## Historic England Response

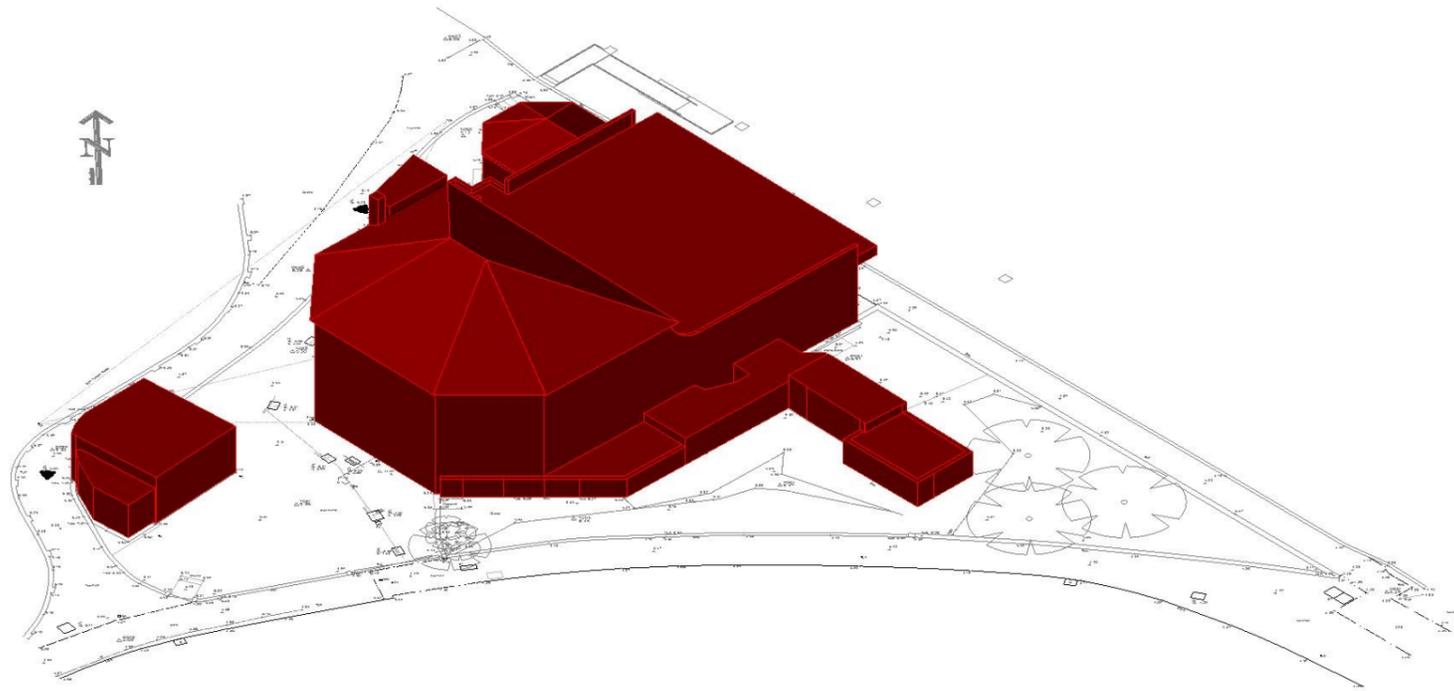
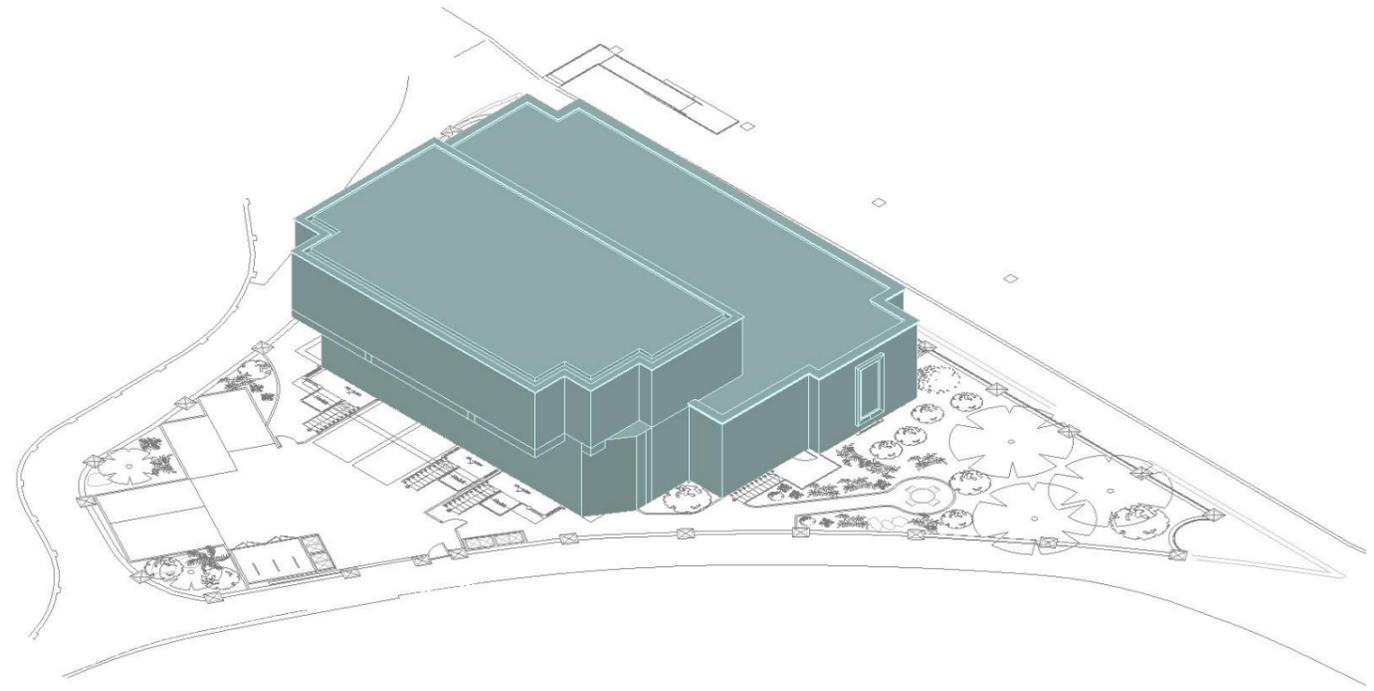
English Heritage Quote from their report "At this scale and with a subtler design we now consider the harm it would cause would be low, at a notably reduced level from all previous iterations of the scheme. Because it would sit below the treeline and thus blend better with intervening tree screening in longer views, we consider the impact on views from within the Old Deer Park would likely be negligible."
